METROPOLITAN GOVERNMENT OF NASHVILLE AND DAVIDSON COUNTY

STAFF RECOMMENDATION
215 Scott Avenue
February 18, 2015

Application: Demolition; New construction-infill
District: Eastwood Neighborhood Conservation Zoning Overlay
Council District: 06
Map and Parcel Number: 08306015100
Applicant: Rob Cushman
Project Lead: Sean Alexander, sean.alexander@nashville.gov

<p>Description of Project: The applicant proposes to demolish a non-contributing building and construct a new one and one-half story duplex.</p> <p>Recommendation Summary: Staff recommends approval of the proposal to demolish the existing building and construct a new duplex with the conditions that:</p> <ul style="list-style-type: none">• Staff verifies that the floor height is compatible with surrounding historic houses;• The window and door selections are approved by Staff;• The roof color is approved by Staff;• The HVAC is located behind the structure or on the sides, beyond the mid-point of the structure. <p>Meeting those conditions, Staff finds that the proposal meets the applicable design guidelines for the Eastwood Neighborhood Conservation Zoning Overlay.</p>	<p>Attachments A: Photographs B: Site Plan C: Elevations</p

215 Scott Avenue, recent photo.

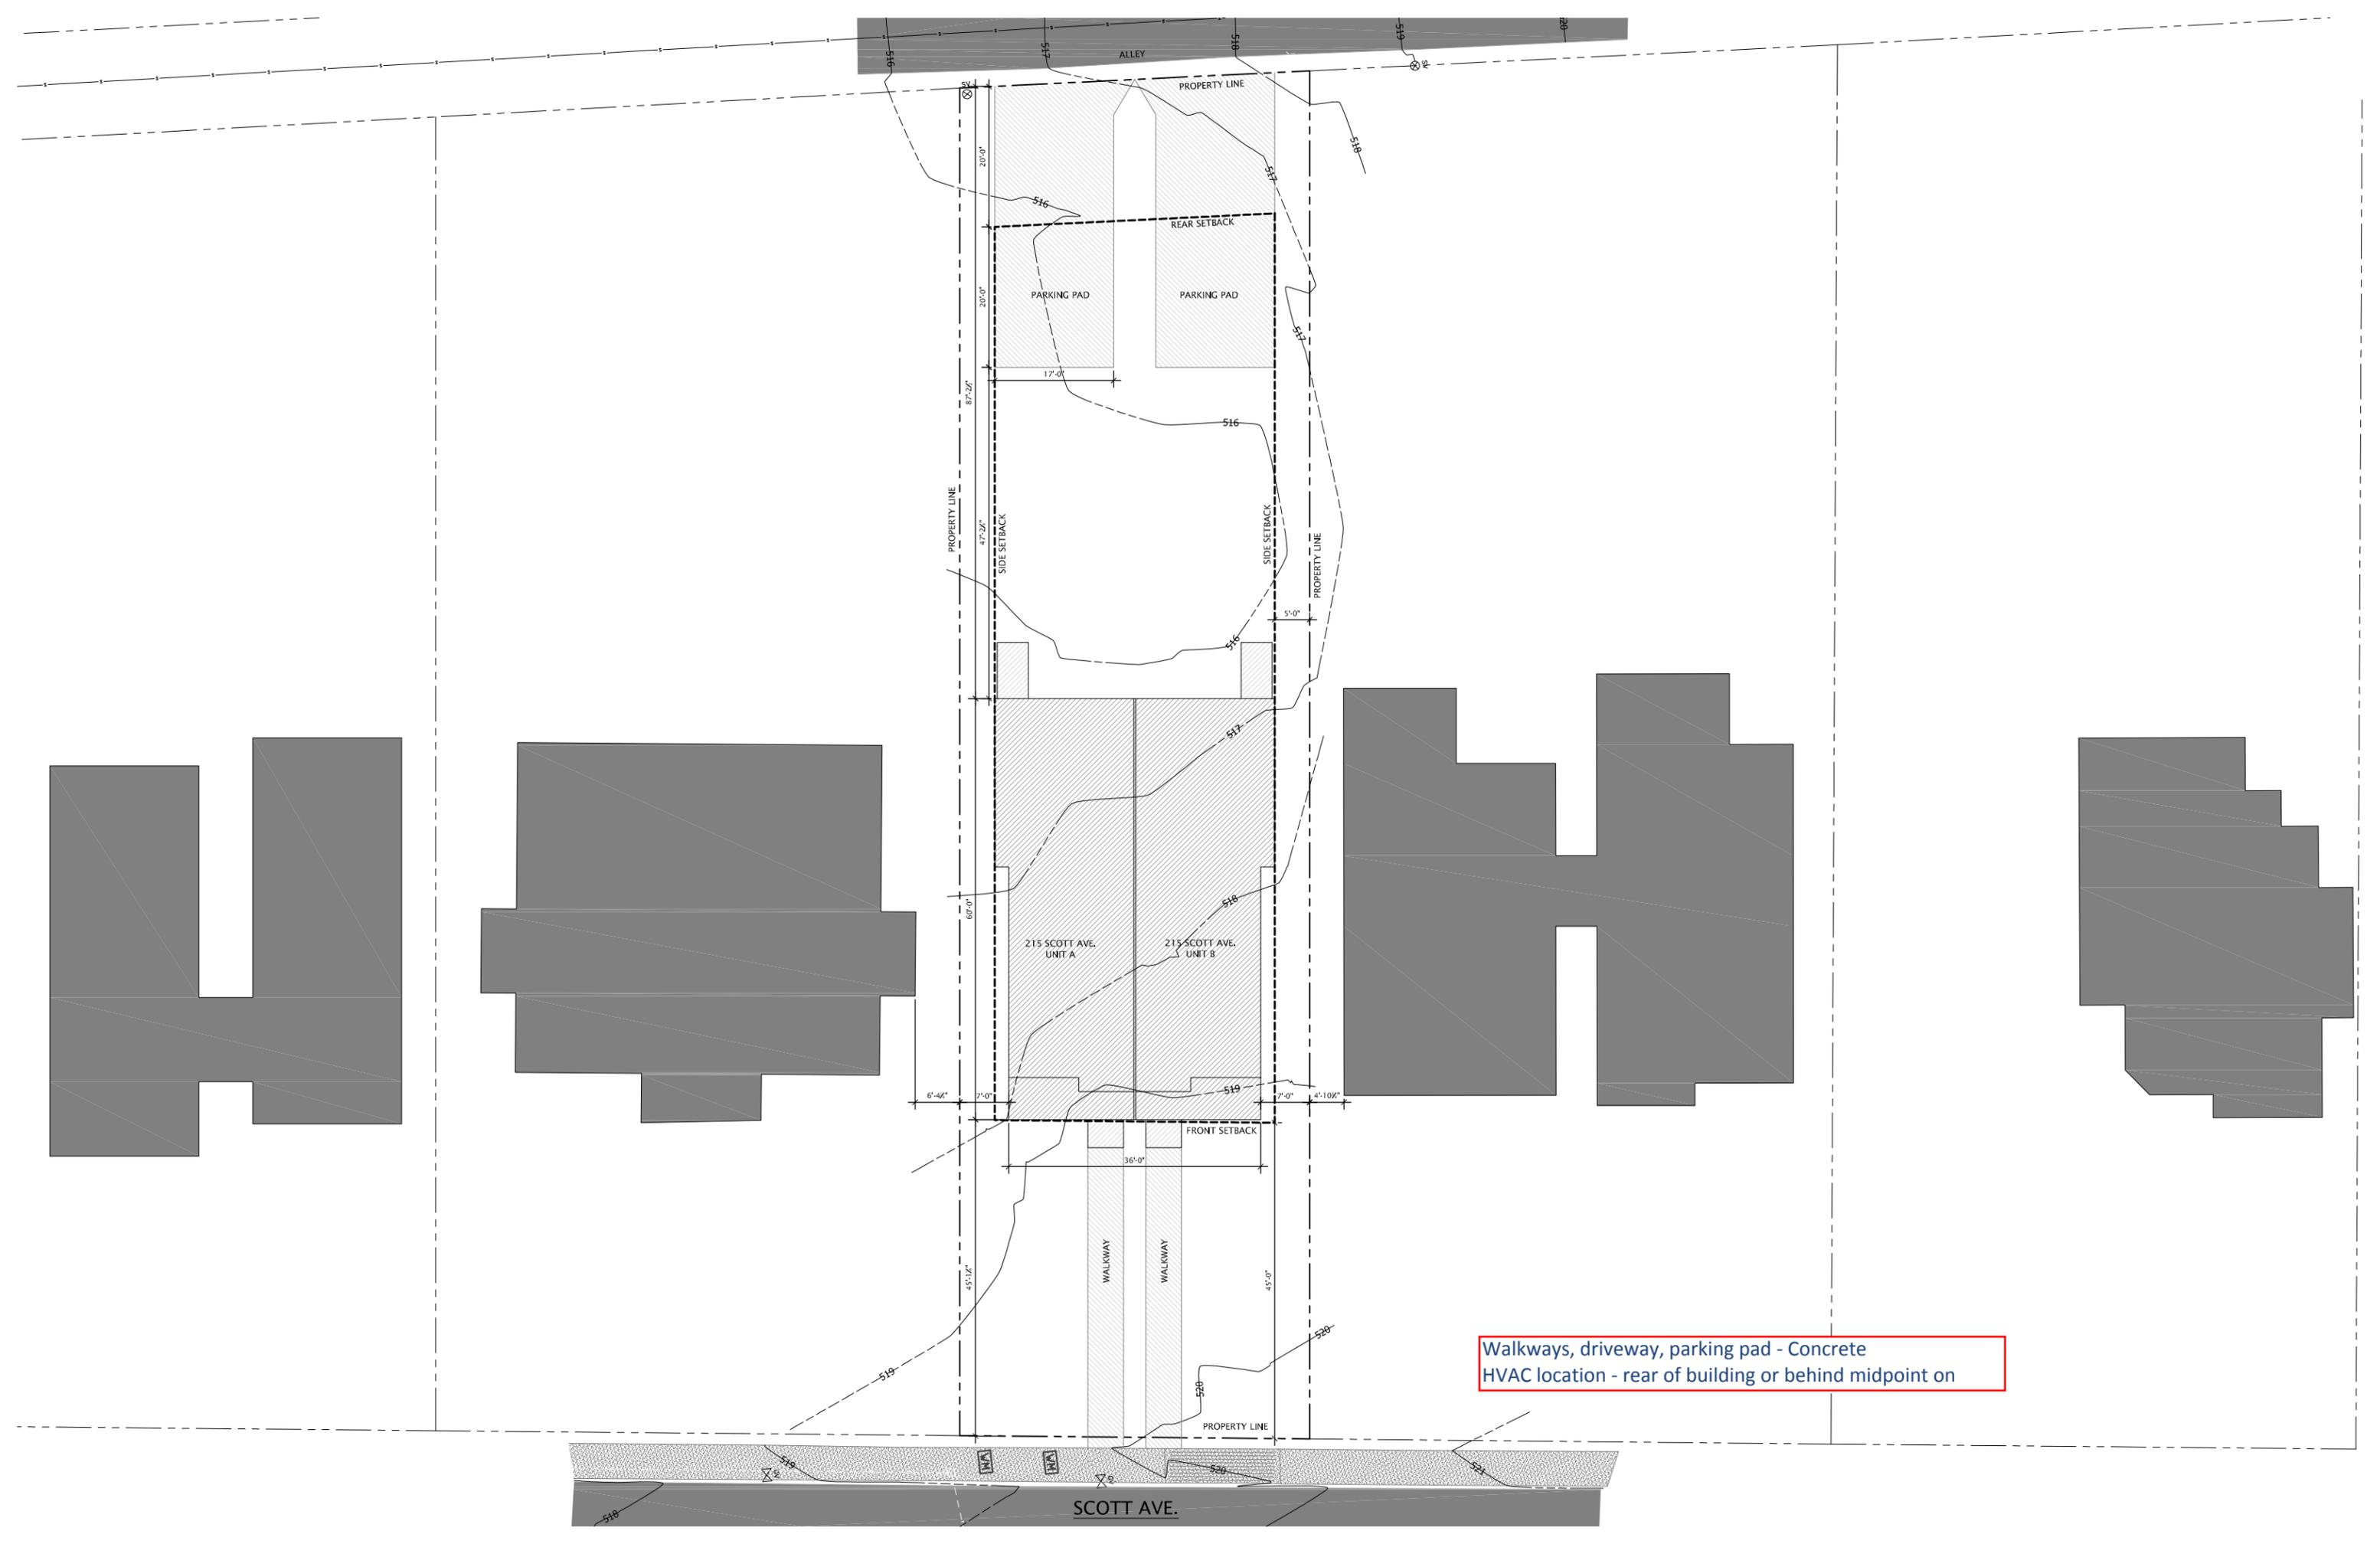
The existing building at 215 Scott Avenue may date to the early 1940s, but its style, form, materials and detailing do not match the historic context of the neighborhood. Its low pitched roof, shallow eaves, irregular fenestration pattern, and materials are inconsistent with the predominant character of development for its time. This suggests that the house may be more recent, or that its appearance has been significantly altered. Staff therefore finds that the structure does not contribute to the architectural and historical character of the district, and that its demolition meets Section III.B.2 for appropriate demolition and does not meet section III.B.1 for inappropriate demolition.

LOWER LEVEL PLAN 965 SQ.FT.
 PER UNIT

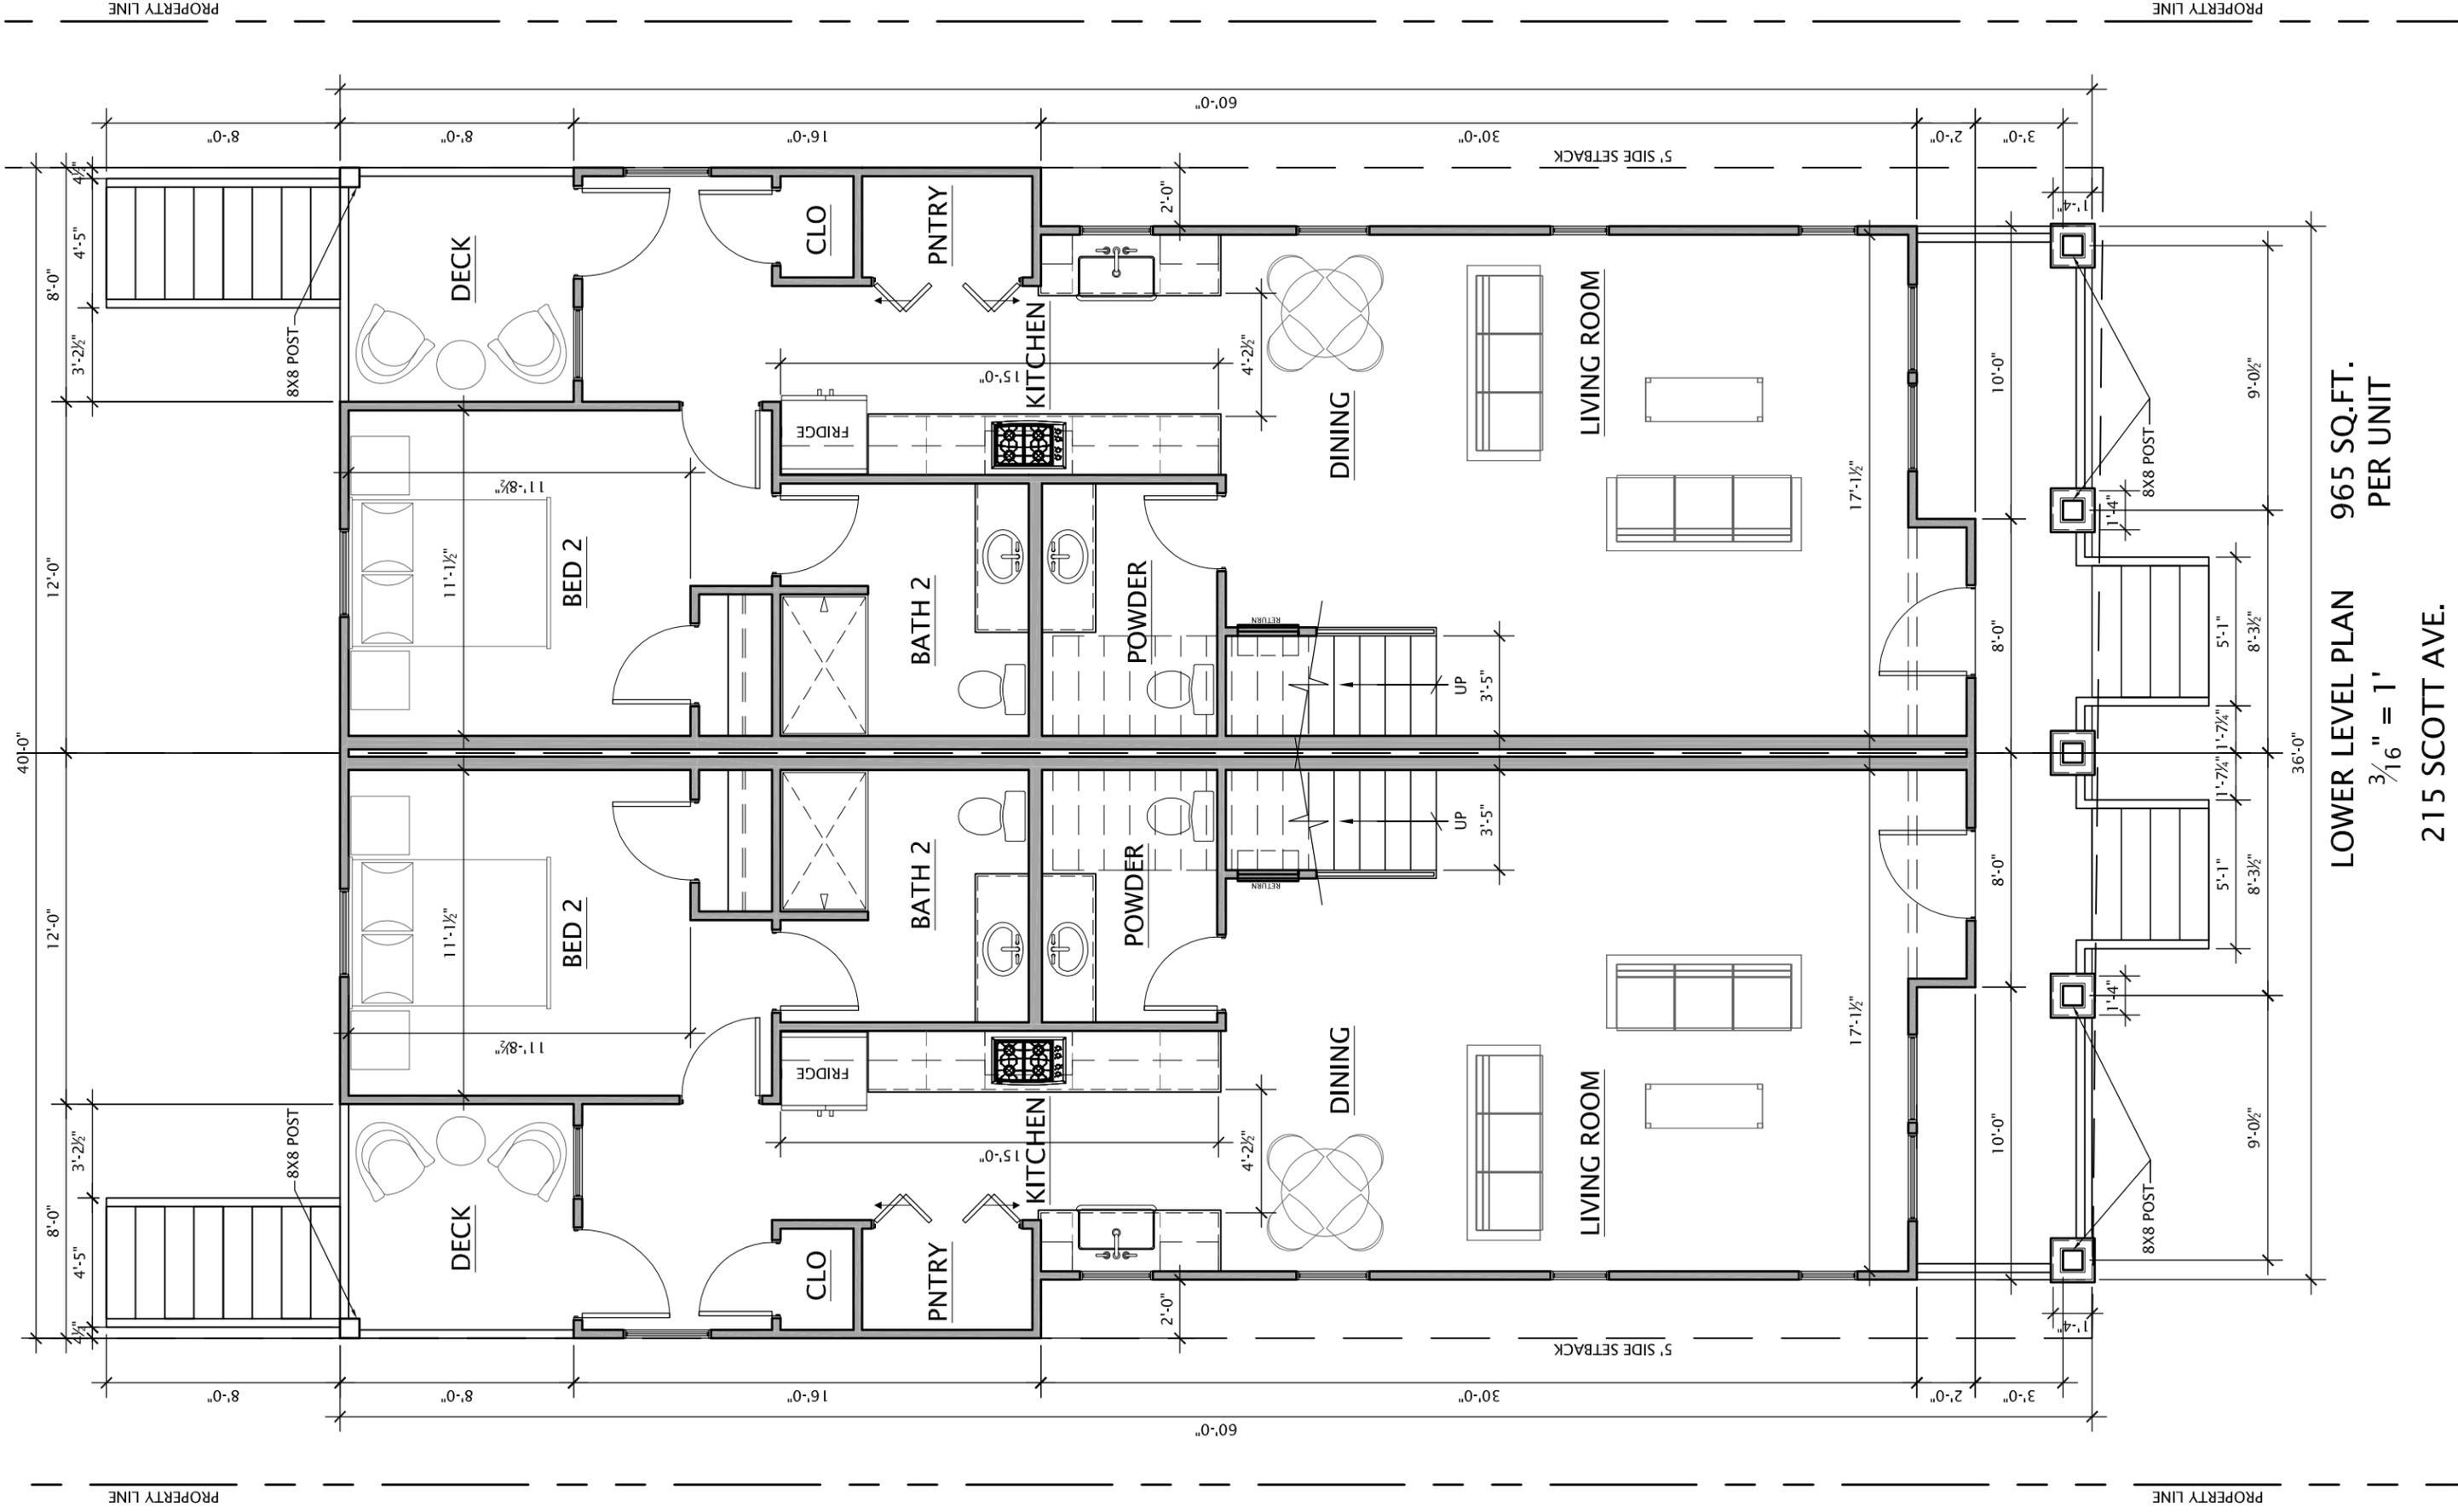
Walkways, driveway, parking pad - Concrete
HVAC location - rear of building or behind midpoint on
